WOLF CREEK NUCLEAR OPERATING CORPORATION

ET 13-0025

Subject: Docket No. 50-482: Wolf Creek Nuclear Operating Corporation's Response to Request for Additional Information Regarding Overall Integrated Plan in Response to March 12, 2012 Commission Order Modifying Licenses with Regard to Reliable Spent Fuel Pool Level Instrumentation (Order EA-12-051)

RESPONSE TO REQUEST FOR ADDITIONAL INFORMATION

- b) A clearly labeled sketch is provided below.

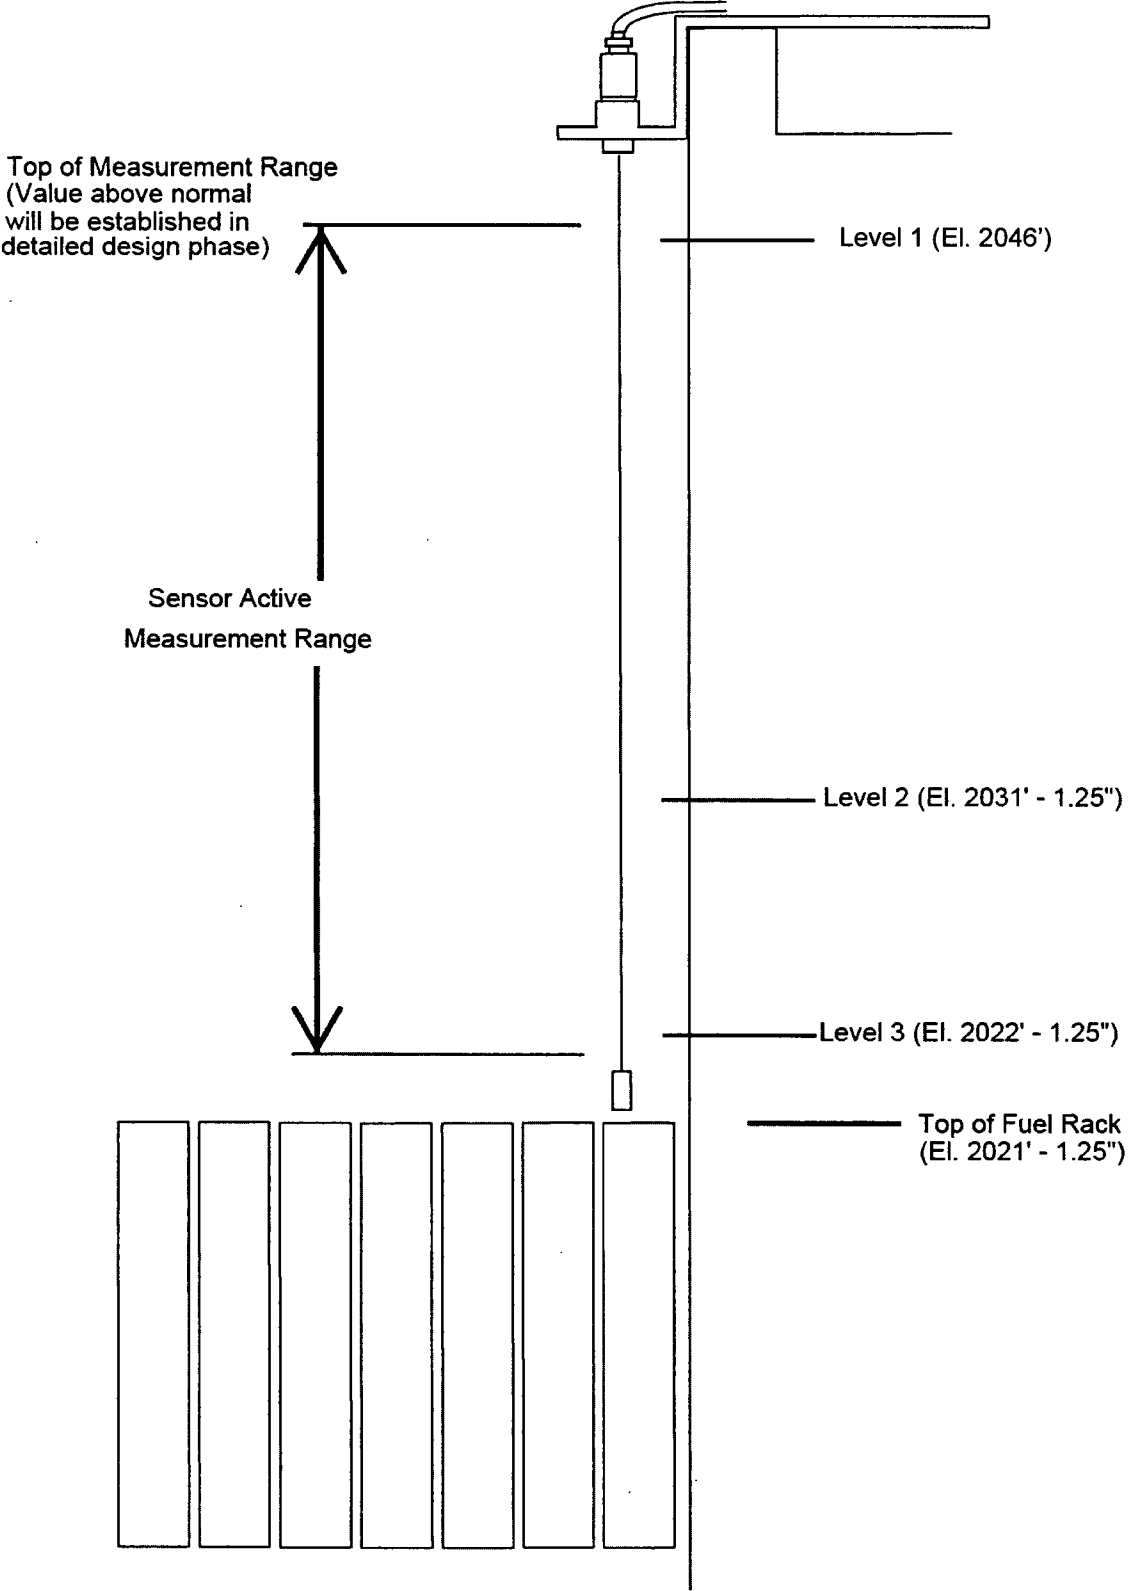
- a) The specific elevations within the plant SFP corresponding to the three levels described in the guidance provided in NEI 12-02, Revision 1. For level 1, specify how the identified location represents the HIGHER of the two points described in the NEI 12-02 guidance for this level.
- b) A clearly labeled sketch depicting the elevation view of the proposed typical mounting arrangement for the portions of the instrument channel consisting of permanent measurement channel equipment (e.g., fixed level sensors and/or stilling wells, and mounting brackets). Please indicate on this sketch the datum values representing Level 1, Level 2, and Level 3 as well as the top of the fuel racks. Indicate on this sketch the portion of the level sensor measurement range that is sensitive to measurement of the fuel pool level, with respect to the Level 1, Level 2, and Level 3 datum points.

- a) Nuclear Energy Institute (NEI) 12-02, "Industry Guidance for Compliance with NRC Order EA-12-051, 'To Modify Licenses with Regard to Reliable Spent Fuel Pool Instrumentation'," Revision 1, specified the higher of the two levels because either condition would compromise continued operation of the normal fuel pool cooling system, and the one reached first on a declining water level depends on plant-specific piping configurations and pump characteristics.

WCNOC designated Level 1 to be Elevation 2046 ft (24 ft, 10.75 in. above the top of the fuel racks). This corresponds to the normal water level. This level is adequate to support operation of the normal fuel pool cooling system, as required by Order EA-12-051. It is a higher level than either of the pump-limiting conditions specified in NEI 12-02, section 2.3.1, and as such, is conservatively safe.

WCNOC designated Level 2 to be the water level 10 ft (\pm 1.0 ft) above the top of the fuel racks. This conforms to one of the two bases for designation specified in NEI 12-02, section 2.3.2. This Spent Fuel Pool (SFP) level is adequate to provide substantial radiation shielding for a person standing on the SFP operating deck at elevation 2047 ft.

WCNOC designated Level 3 to be the water level "greater than 1 ft above the top of the fuel storage racks plus the accuracy of the SFP level instrument channel, which is to be determined." This is consistent with the "nominal" "highest point of any fuel rack..." characterization of NEI 12-02, section 2.3.3. Designation of this level as Level 3 is conservative; its selection assures that the fuel will remain covered, and at that point there would be no functional or operational reason to defer action to implement the addition of make-up water to the pool.

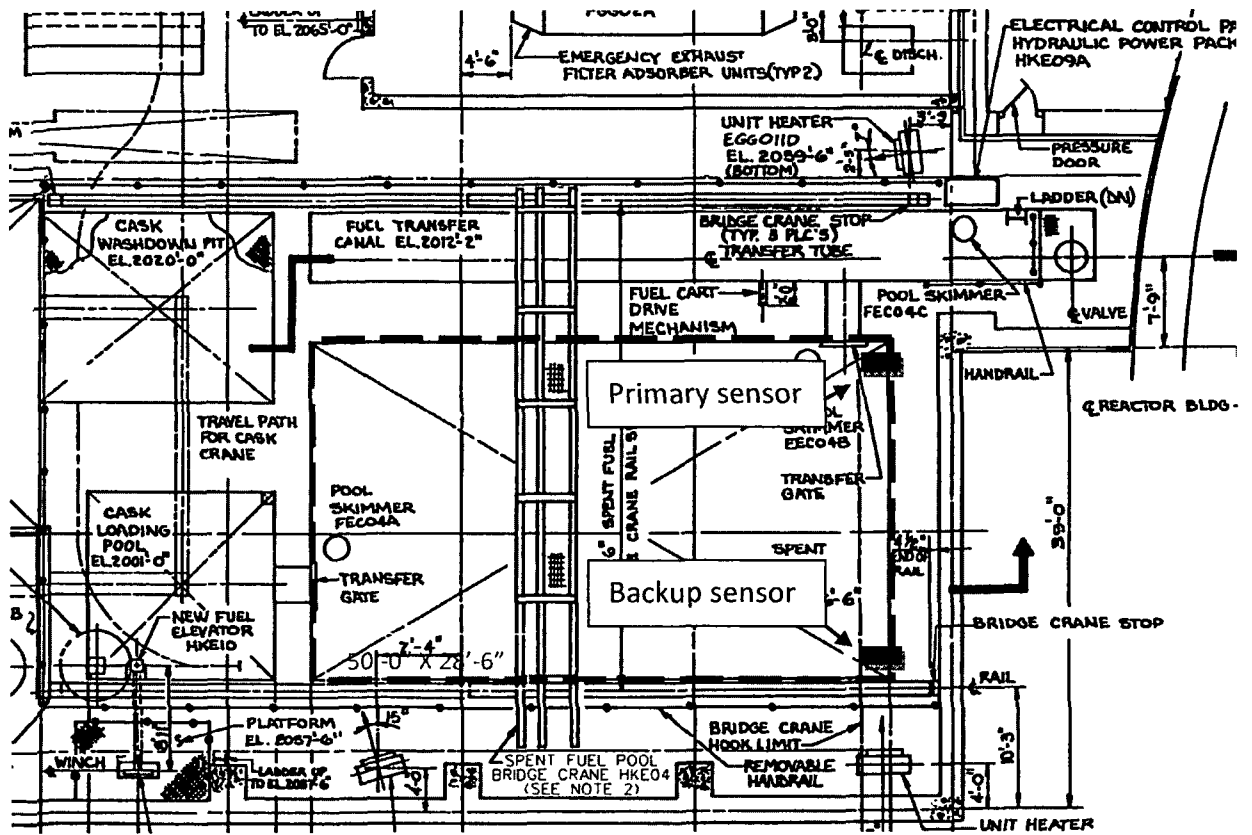
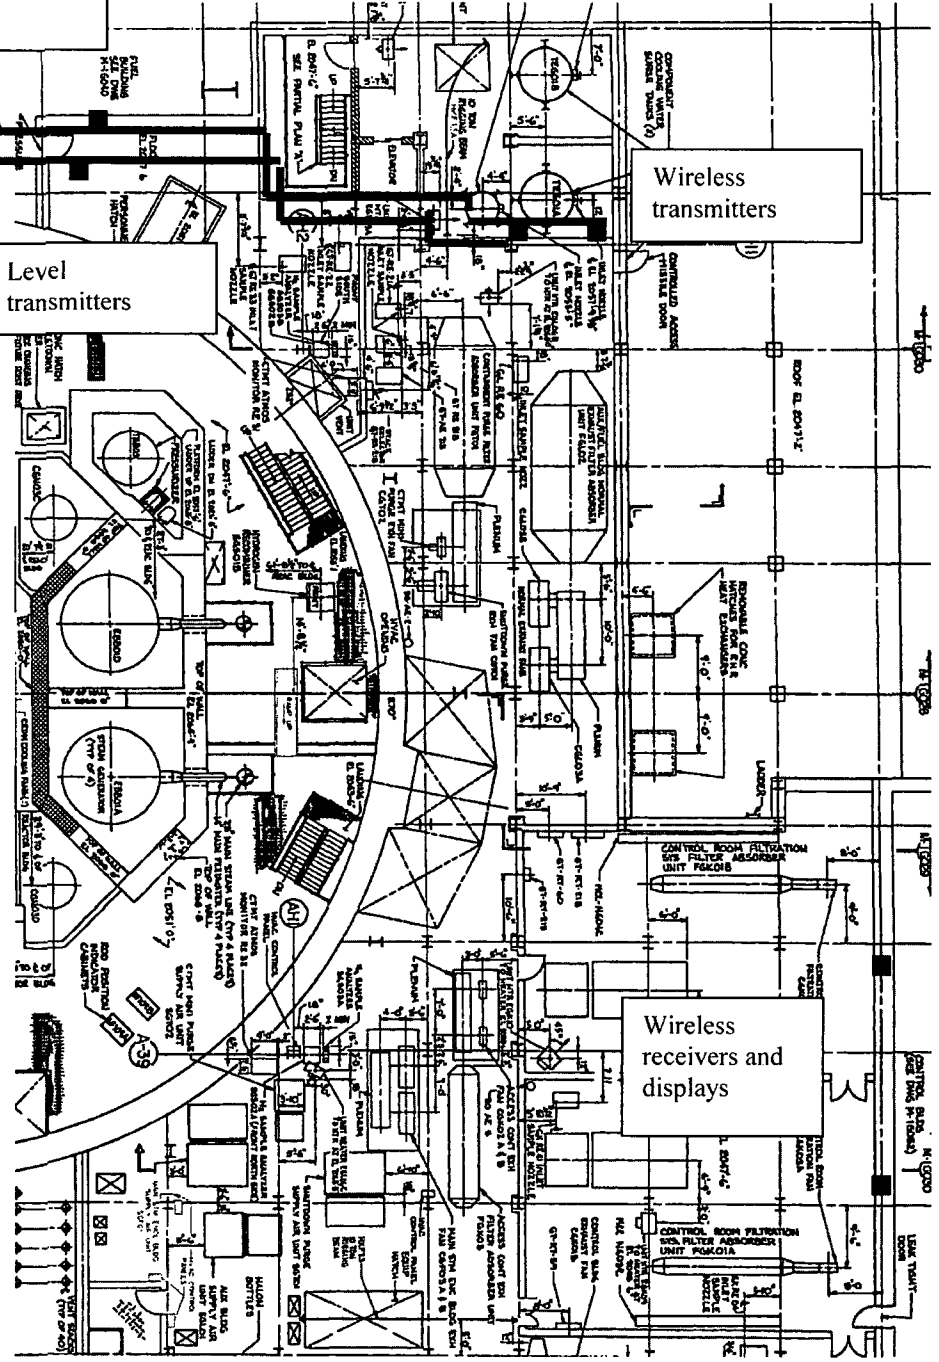
- a) Please provide a clearly labeled sketch or marked-up plant drawing of the plan view of the SFP area, depicting the SFP inside dimensions, the planned locations/placement of the primary and backup SFP level sensor, and the proposed routing of the cables that will extend from the sensors toward the location of the read-out/display device.

- a) Below are excerpts from plant drawings being used as sketches that depict the conceptual locations of the two permanently mounted level probes (primary and backup) within the SFP area and the cable routing to locate the electronics to a non-harsh environment outside the SFP area.

The inside dimensions of the SFP are 50 ft – 0 in. by 28 ft – 6 in.

The recognized displays will be located in the Control Room A/C Unit and Filtration Units Rooms "A" and "B" which are adjacent to the control room. These rooms are accessible during and after an event occurs.

Figure 1: Top View of SFP Instrumentation pedestal

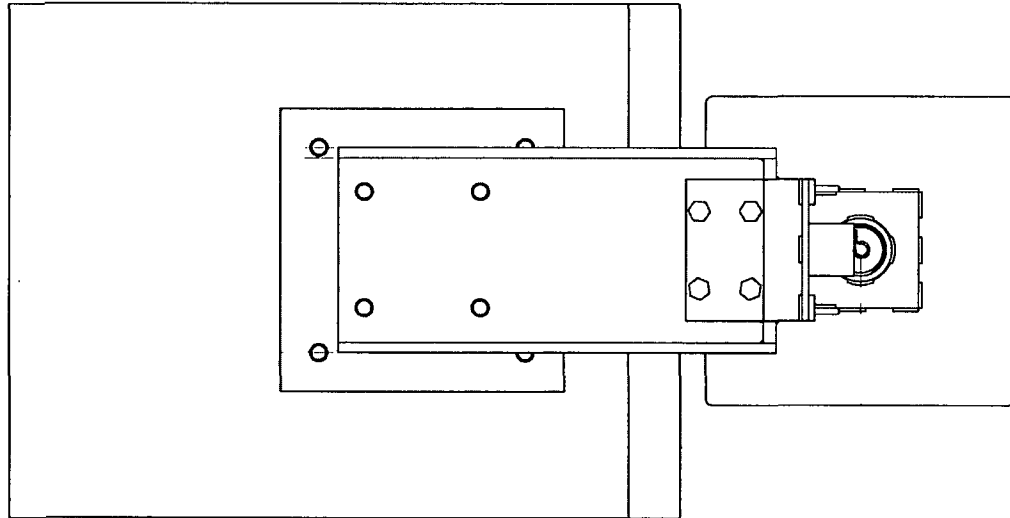
- b) A description of the manner in which the level sensor (and stilling well, if appropriate) will be attached to the refueling floor and/or other support structures for each planned point of attachment of the probe assembly. Please indicate in a schematic the portions of the level sensor that will serve as points of attachment for mechanical/mounting or electrical connections.

- b) Figure 1 shows a top view of the pedestal (stainless steel tube welded to the base plate and the channel shown in the figure) that will attach to the refuel deck. The bracket will be attached to the refuel deck using installed anchors that will be designed according to the plant existing specification for design of concrete anchors. The pedestal will be

adjusted to the height of the poolside curb to ensure the SFP bracket extends over the pool horizontally level.

Figure 2 – Spent Fuel Pool Sensor Bracket Mounting Details

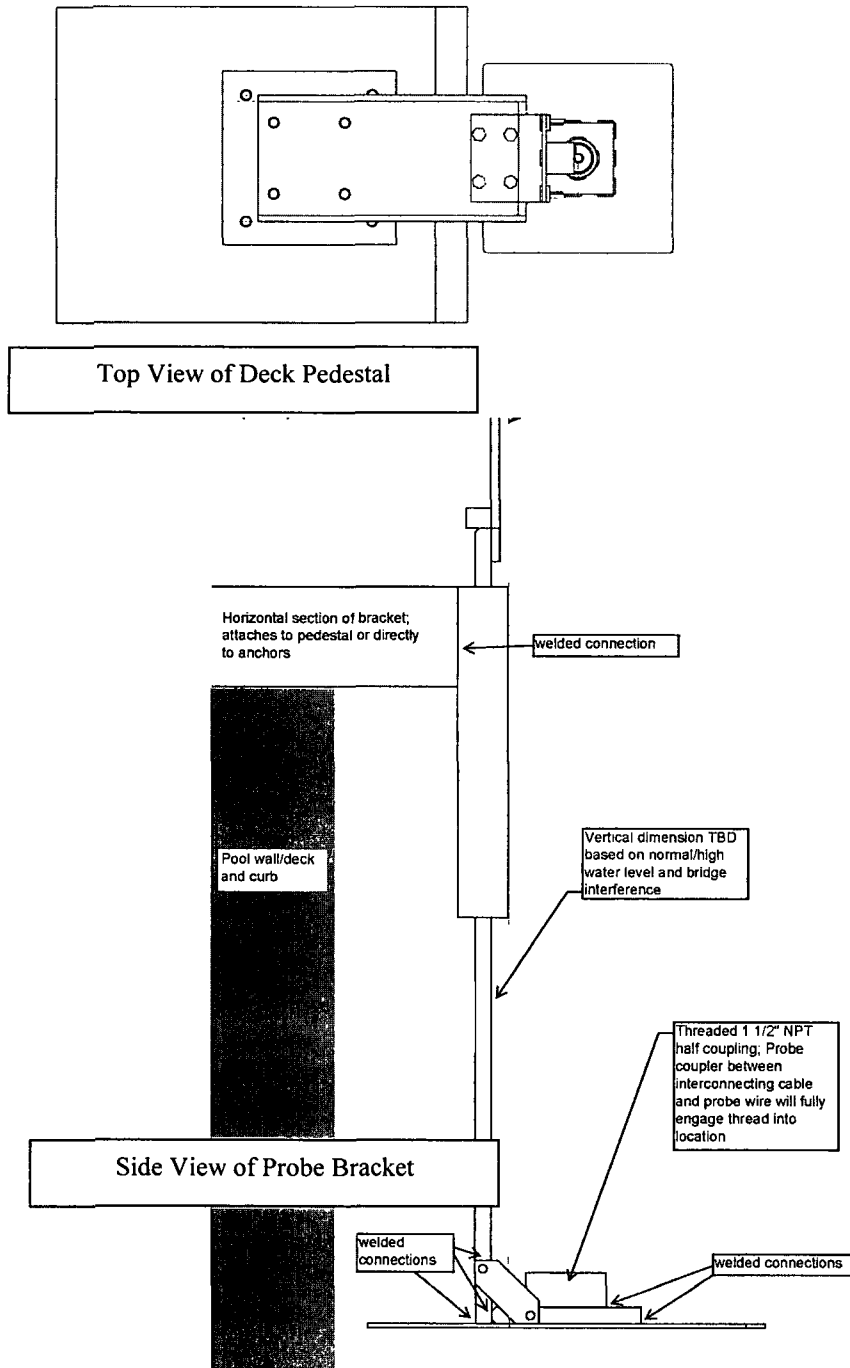
- c) A description of the manner by which the mechanical connections will attach the level instrument to permanent SFP structures so as to support the level sensor assembly.

The probe attaches to the bracket via a 1½ in. National Pipe Thread Taper (NPT) connection. Figure 2 details the vertical portion of the bracket where the probe will thread into the bracket. All non-movable connections of parts will be welded during manufacturing.

- c) The attachment of the seismically qualified bracket to the refuel deck will be through permanently installed anchors that will be designed according to the plant existing specification for design of concrete anchors. With the permanently installed anchors, the pedestal will be secured to the refuel deck with adequate washers and bolts and the pedestal will attach to the bracket with adequate washers and bolts.

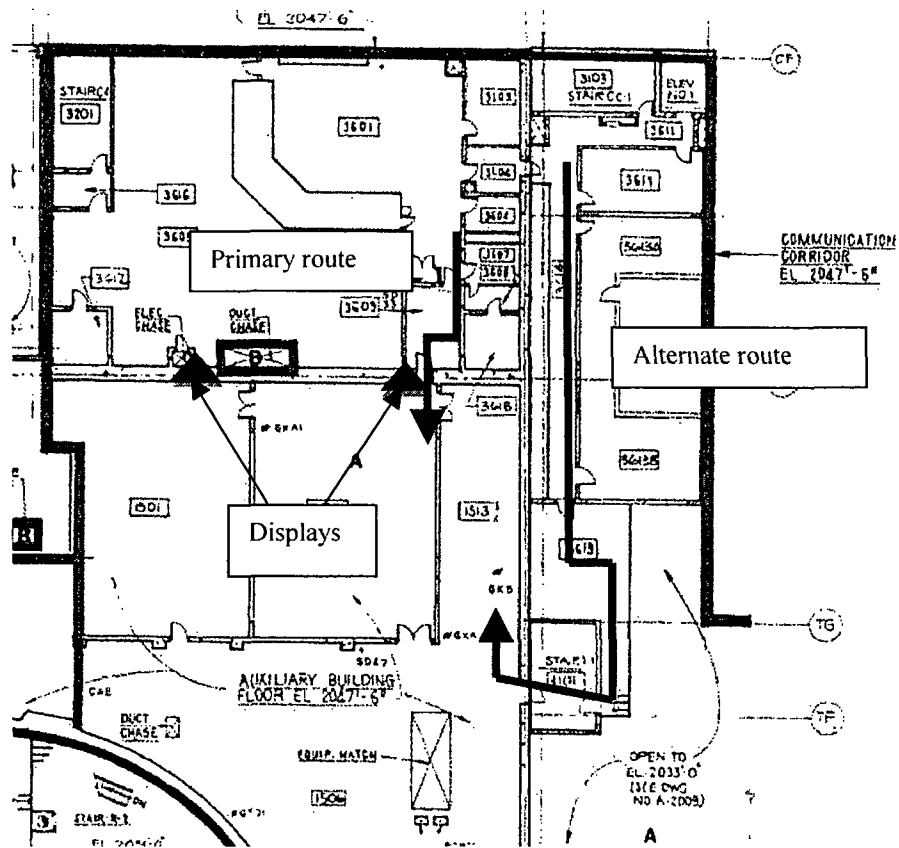
- a) The specific location for the primary and backup instrument channel display.
- b) Since the licensee has not committed to place the primary and backup displays in the main control room, please provide a description of the location for the primary and backup display, including primary and alternate route evaluation, habitability at display location(s), continual resource availability for personnel responsible to promptly read displays, and provisions for communications with decision makers for the various SFP drain down scenarios and external events.
- c) The reasons justifying why the locations selected will enable the information from these instruments to be considered "promptly accessible." Please include consideration of various drain-down scenarios.

- a) The primary display will be located in the Control Room A/C Unit and Filtration Units Room "A", Room 1512 Elevation 2047 ft - 6 in., on the approximate centerline of the Plant West wall. The backup display will be located in the Control Room A/C Unit and Filtration Units Room "B", Room 1501 Elevation 2047 ft - 6 in., on the approximate centerline of the Plant West wall.

- b) Below is an excerpt of a plant drawing being used as a sketch showing the locations of the displays and the control room. The displays are on the wall separating the control room from the Auxiliary Building, to the Plant East. The displays can be promptly viewed by control room staff due an access from the control room to the Control Room A/C Unit and Filtration Units Room "A". An alternate path can be utilized through the Communication Corridor, into the Auxiliary Building and into either the Control Room A/C Unit and Filtration Units Room "A" or "B". During and after an event, the area of the displays will be accessible by Operations personnel from the control room. The Control Room A/C Unit and Filtration Units Rooms "A" and "B" are located in the control room envelope. The control room envelope is isolated and pressurized during an accident involving the release of radioactive gases in the surrounding zones. Due to the close proximity between the control room and the display locations, use of wireless handheld radios or other equipment for communications will not be necessary.
